HVJ TRANSPORT LTD

Project: Construction of five attached two bedroom dwellings

Project No.: P1095

Date: September 2021

Figure 3: Pedestrian connectivity

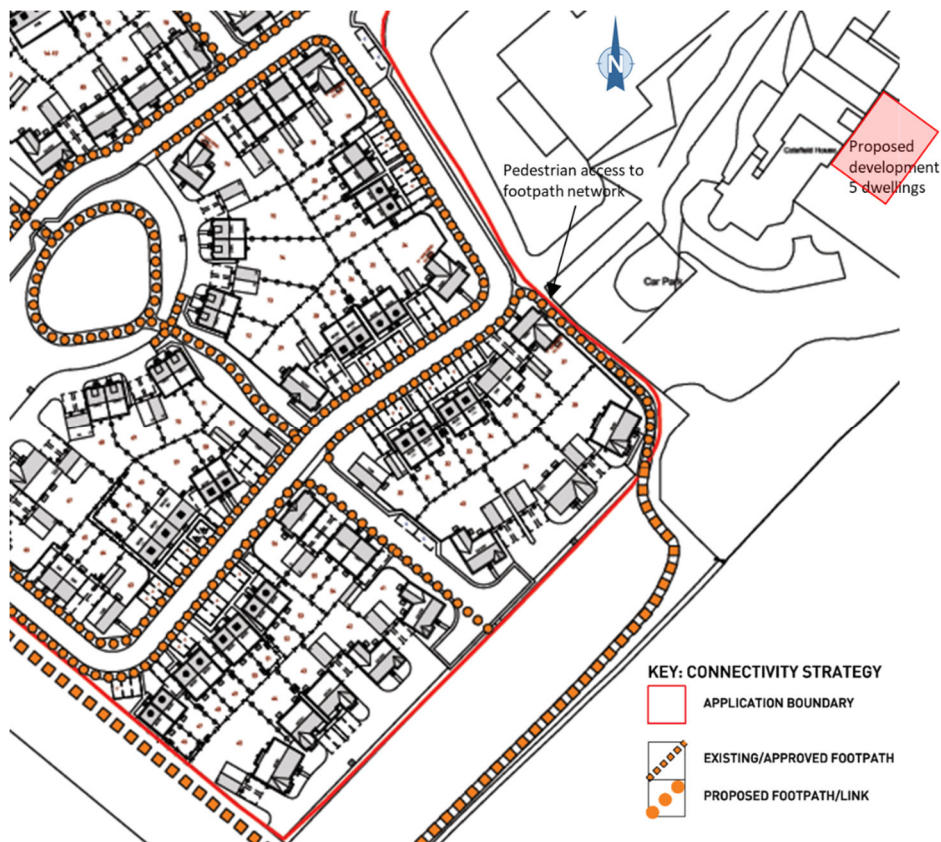
3.4 A lack of facilities for pedestrians or cyclists to safely use the legal access route has been suggested by OCC. As shown in Figure 2, the section of access in question is 26m long and varies in width between 3.3m and 4.0m. Photos 2 and 3 highlight the open expanse of area on either side of the access which ensures ample visibility for all users of this space.

- 3.9 As can be seen in Figure 3, there is a direct means of access to a recently constructed footway along the southwest boundary of the site. This affords residents of Cotefield House and the new development an alternative option for connecting to the footway network and the A4260 footways.
